Subject: Southwestern Parkway Storage Basin

Minor Project Modification

IOAP Project No. L_OR_MF_105_M_13_B_A_0

CSO Project Fact Sheet 2015 IOAP Project Modification

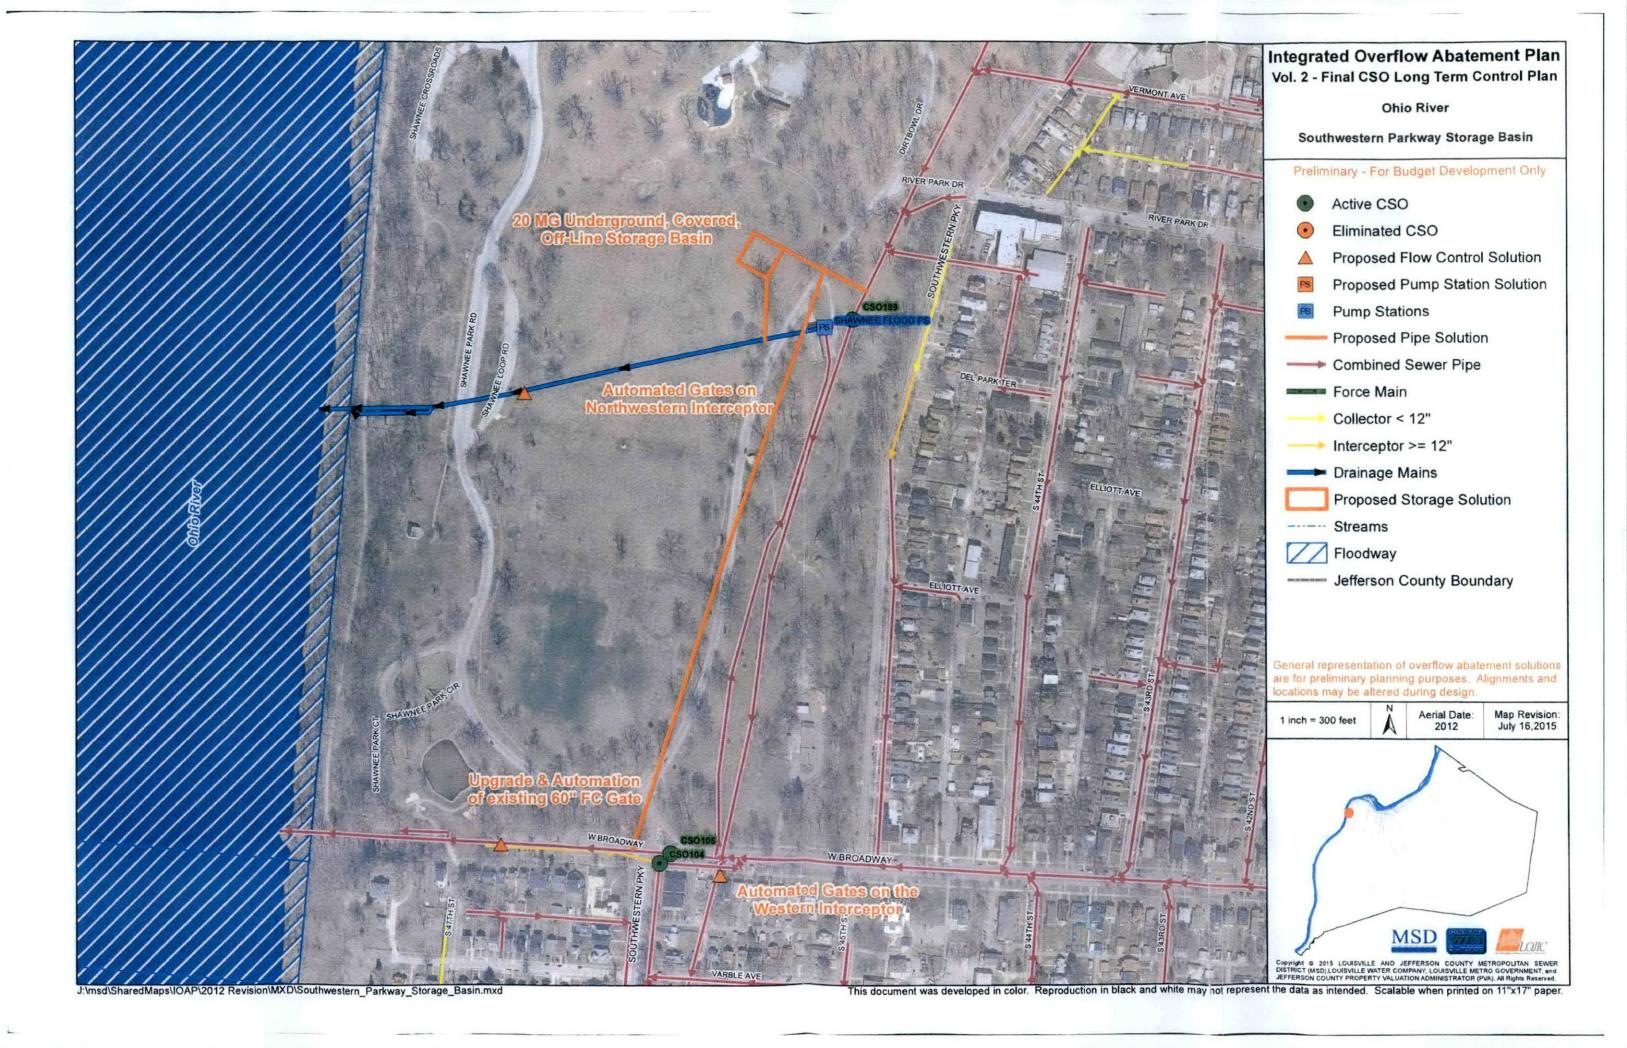
Regarding the design clarification, the 2015 minor project modification submittal included the use of inline storage in the Western Outfall and Northwestern Interceptor upstream of the proposed CSO diversion structures as well as downstream of the proposed CSO structures. To provide inline storage downstream, the existing flood control gates would need to be modified and used. MSD determined that dual use of the gates for flood control and overflow abatement could result in numerous operational and construction concerns potentially affecting public health and safety, and elected to utilize approximately 6.3 MG of inline storage upstream. The basin had initially been resized to 17.5 MG assuming the use of the 8.8 MG of inline storage described in 2012. Since MSD determined that only 6.3 MG of inline storage is available upstream of the basin, the basin was resized to 20 MG to meet the level of control of 8 overflows per Typical Year. The reduction in inline storage was mistakenly not reflected in the project fact sheet accompanying the 2015 modification. The level of control and overall storage volume for the basin project as a whole will not change.

For your reference, a copy of the project fact sheets and maps from the minor project modification approved in September 2015 are included in Attachment A. New project fact sheets and maps addressing this clarification request have been provided in Attachment B.

Project Description: This project includes a 20 MG underground covered concrete basin for CSO104, 105, and 189 and in-line storage

in the Western Outfall and the Northwest Interceptor for approximately 6.3 MG using adjustable gates to reduce

overflows to eight overflows per typical year.
